# **Proposed Marlborough Environment Plan**

**Section 42A Hearings Report for Hearing Commencing  
19 February 2018**

**Supplementary Report dated: 11 December 2017**

**Report on submissions and further submissions  
Topic 5: Natural Character – Technical Mapping,  
Values and Overlays**

*Image: Excerpt of Image 5 illustrated on page 34 of the Natural Character – Technical Mapping, Values and Overlays report, dated 20 November 2017, illustrating the sub-areas of Pelorus Sound relevant to these additional submission points.*

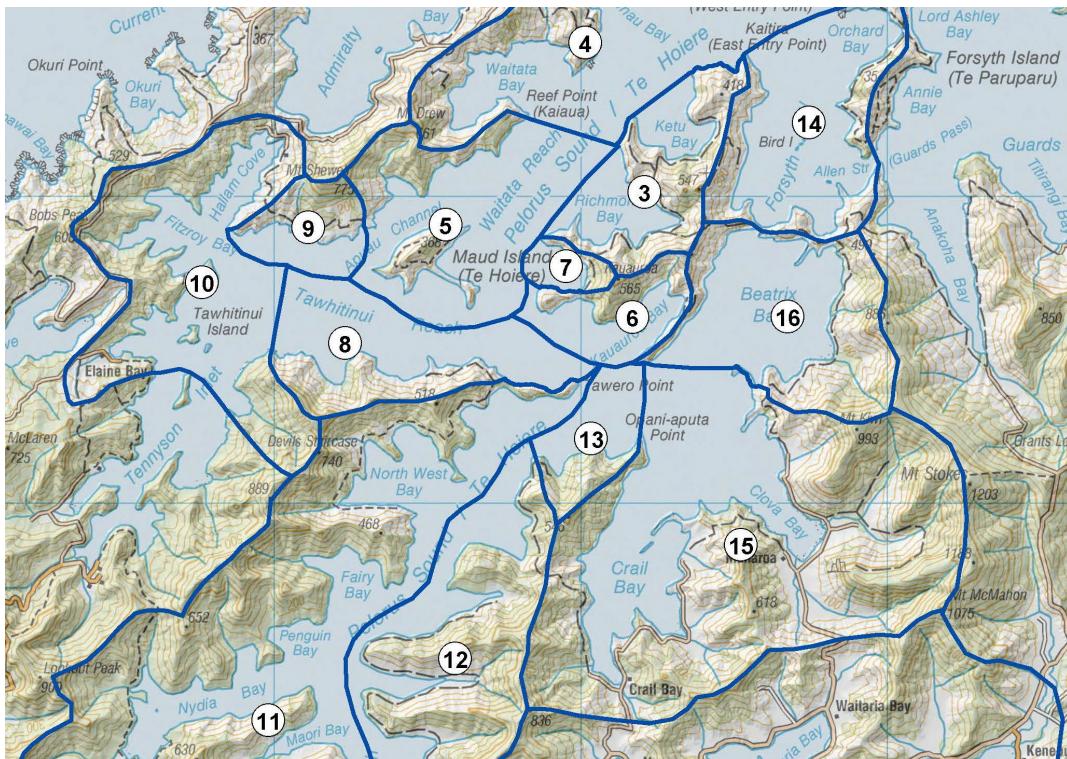
- Amend the HNC over Maud Island so that it does not extent over coastal waters (i.e. the boundary is MHWS).
- Delete the coastal parts of the VHNC around Wilson Bay/Spencer Point.
- Delete the HNC zone at and near Mt Shewell.

Both submissions request an amendment or deletion to the extent of the natural character overlays. All three of the requests mentioned above appear within the Pelorus Sound Coastal Marine Area (C) and each within different sub-areas of the Sounds, as mapped on page 34 of the Natural Character – Technical Mapping, Values and Overlays report, dated 20 November 2017, with an excerpt of that plan outlined below:

The submitter requests deletion of the coastal parts of the VHNC around Wilson Bay/Spencer Point. On page 48 of the Natural Character – Technical Mapping, Values and Overlays report, I commence the discussion in this area. Other submitters seek similar requests within this area, with Submitters 842 and 1160 also seeking a similar relief in terms of removing the VHNC of the seascape south of Tawero Point and Wilson Bay.

The tenor of my discussion focussed on the very high levels of natural character evident within this part of the Inner Marlborough Sounds. The area of VHNC within the coastal marine area is mapped at the Level 4 scale, and whilst there are small areas of modification, these have not directly affected the broad mapping of this stretch of coastal water to any degree that these areas should be excluded. Based on this, I am comfortable with the natural character mapping in this area at the scale undertaken.

That the HNC associated around the waters of Maud Island are not deleted.

*'I therefore recommend that the area of high natural character east of Picnic Bay be unmapped based on its level of modification and that the upper part of Mt. Shewell be considered very high. This is reflected on Figure G: Natural Character Mapping Change 7: Northern Tawhitinui Reach'.*

That no change occurs to the natural character mapping around the coastal parts of the VHNC around Wilson Bay/Spencer Point
